## Product Change Notification - SYST-22TUUQ918

Data Sheet - AT24C32D - Complete Datasheet

**Description of Change:** 1) Updated to the Microchip template. Microchip DS20006047 replaces Atmel document 8866. 2) Corrected tLOW typo from 400 ns to 500 ns. 3) Corrected tAA typo from 550 ns to 450 ns. 4) Updated Part Marking Information. 5) Updated the "Software Reset" section. 6) Added ESD rating. 7) Removed lead finish designation. 8) Updated trace code format in package markings. 9) Updated section content throughout for clarification. 10) Added a figure for "System Configuration Using 2-Wire Serial EEPROMs". 11) Added POR recommendations section. 12) Removed the 5-ball WLCSP package offering. 13) Replaced the 8U2-1 VFBGA Package Outline Drawing with the 8U3-1 VFBGA Package Outline Drawing. 14) Updated the SOIC, TSSOP and UDFN package drawings to Microchip format.

**Figure 5-2. Software Reset**

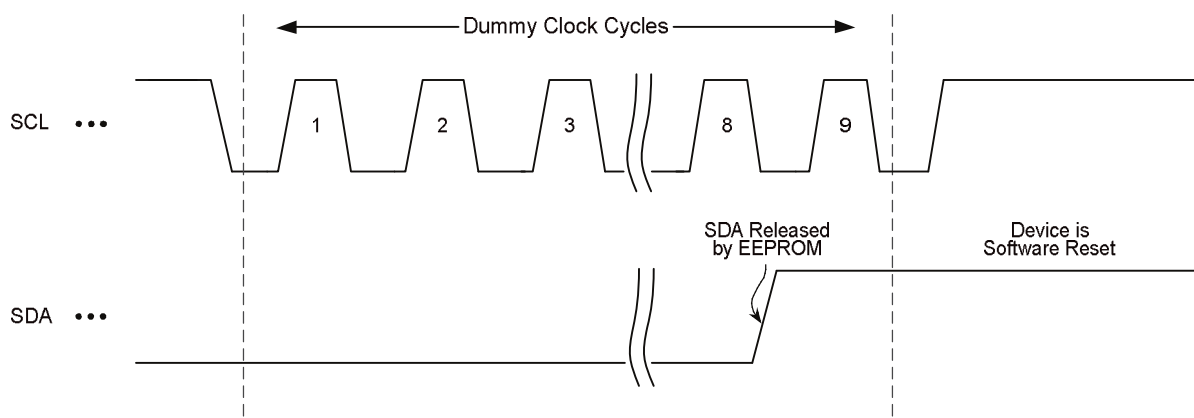
Updated to the Microchip template. Microchip DS20006047 replaces Atmel document 8866. Corrected  $t_{LOW}$  typo from 400 ns to 500 ns. Corrected  $t_{AA}$  typo from 550 ns to 450 ns. Updated Part Marking Information. Updated the "Software Reset" section. Added ESD rating. Removed lead finish designation. Updated trace code format in package markings. Updated section content throughout for clarification. Added a figure for "System Configuration Using 2-Wire Serial EEPROMs". Added POR recommendations section. Removed the 5-ball WLCSP package offering. Replaced the 8U2-1 VFBGA Package Outline Drawing with the 8U3-1 VFBGA Package Outline Drawing. Updated the SOIC, TSSOP and UDFN package drawings to Microchip format.
